NUREG-1923

Safety Evaluation Report for an  
Early Site Permit (ESP) at the  
Vogtle Electric Generating  
Plant (VEGP) ESP Site

This safety evaluation report<sup>1</sup> (SER) documents the U.S. Nuclear Regulatory Commission (NRC) staff's technical review of the site safety analysis report (SSAR) and emergency planning information included in the early site permit (ESP) application submitted by Southern Nuclear Operating Company (SNC or the applicant), for the Vogtle Electric Generating Plant (Vogtle or VEGP) site. The SER also documents the NRC staff's technical review of the limited work authorization (LWA) activities for which SNC has requested approval.

**Figure 2.5.1-4 - Local Charleston Tectonic Features  
(Reproduced from SSAR Figure 2.5.1-19)**

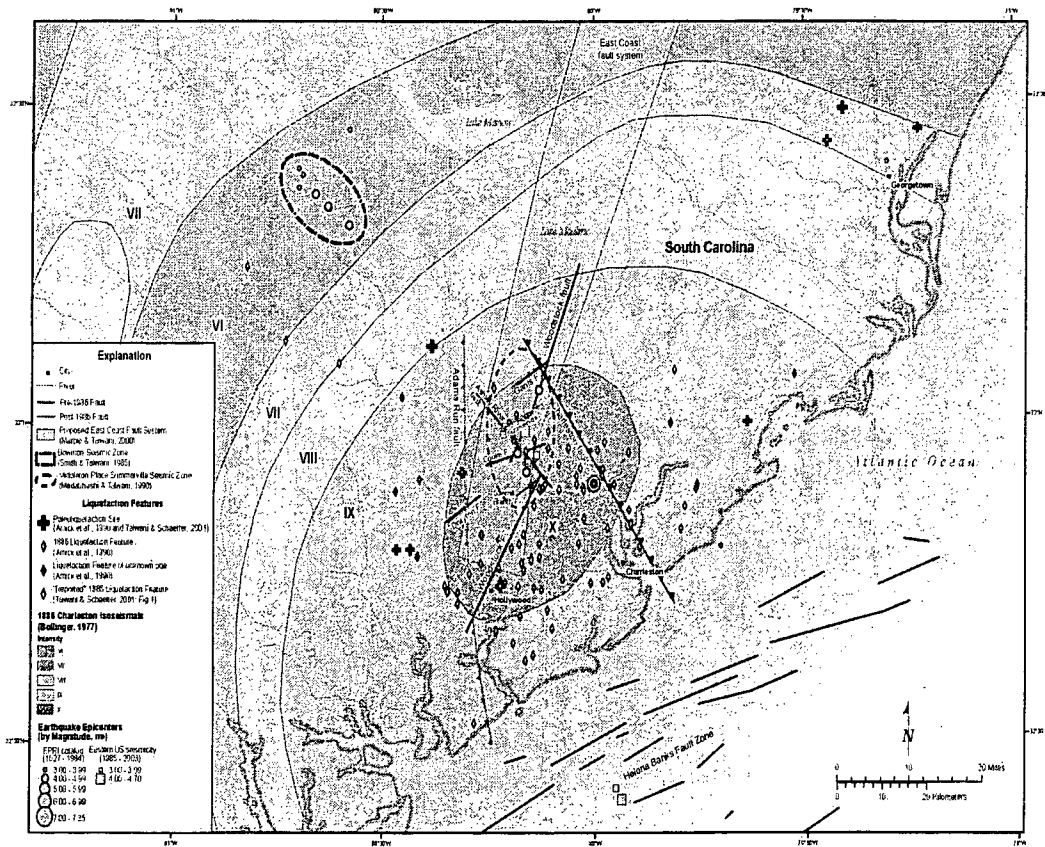
2. The applicant documented that the Bowman seismic zone lies outside the meizoseismal area of the 1886 Charleston earthquake. It is located about 80 km (50 mi) northwest of Charleston and 96 km (60 mi) east-northeast of the VEGP site as shown in Figure 2.5.1-4. The zone was identified based on a series of earthquakes with magnitudes of M3-4 which occurred in that zone between 1971-1974.
3. The applicant described the Adams Run seismic zone, located within the meizoseismal area of the 1886 Charleston earthquake as being defined by four earthquakes with magnitudes less than M2.5. Three of these four earthquakes occurred over a two day period in December 1977. This seismic zone occurs about 120 km (75 mi) east-southeast of the VEGP site and is not shown in Figure 2.5.1-4 as the text indicates.

**Figure 2.5.1-8 - Location of the Pen Branch Fault  
(Reproduced from SSAR Figure 2.5.1-34)**

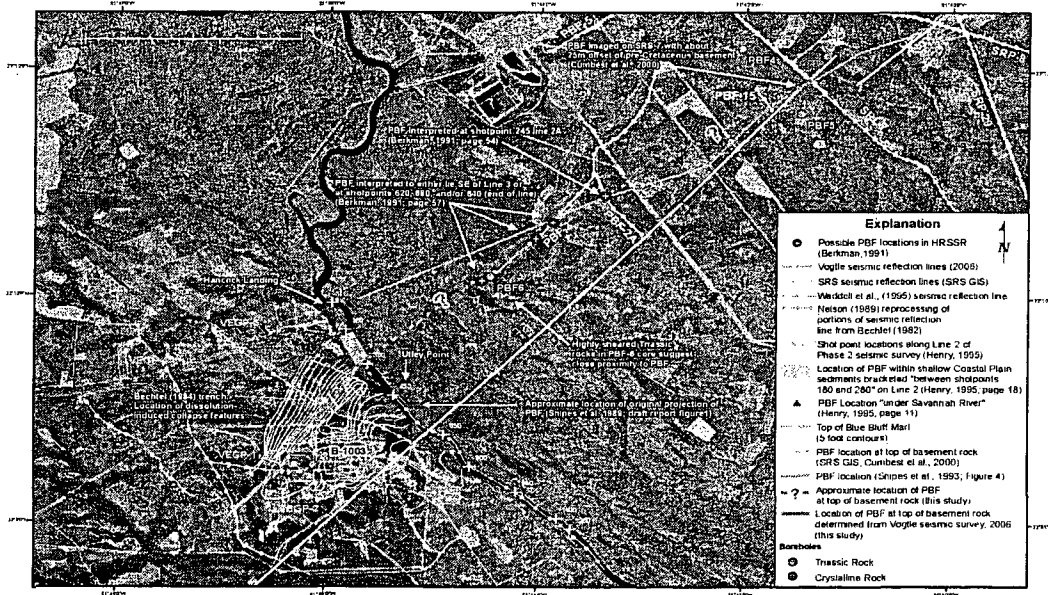
Based on an evaluation of the applicant's response, the staff concludes that, since the terraces are regional in extent, it is highly unlikely that they developed due to tectonic displacement along the Pen Branch fault. The trace of the fault is nearly perpendicular to the long axis of the terrace surfaces (see SSAR Figure 2.5.1-43), so the terraces are favorably oriented to register Quaternary deformation along the Pen Branch fault. Alternatively, the staff believes a more likely origin for the terraces involves regional changes in sea level relative to the continental land mass. These regional changes resulted from either climatic, isostatic, or eustatic effects or some combination of these nontectonic mechanisms. Climatic, isostatic, and eustatic perturbations alter sea level relative to the land mass on a regional scale, either by raising the sea level itself (climatic and eustatic changes) or isostatically uplifting blocks of continental crust due to regional crustal unloading (isostatic changes). The mechanism of tectonic perturbations is separate and distinct from these regional changes in sea level and would involve tectonic uplift (e.g., fault displacement) to raise a fault block and produce abandoned fluvial terraces atop that block. The staff's conclusion that the fluvial terraces developed as a result of nontectonic processes rather than by tectonic uplift is based on the staff's evaluation of the applicant's response to RAI 2.5.1-1, and subsequent RAI responses pertaining to the same subject (i.e., RAI 2.5.1-2 and RAI 2.5.1-3).
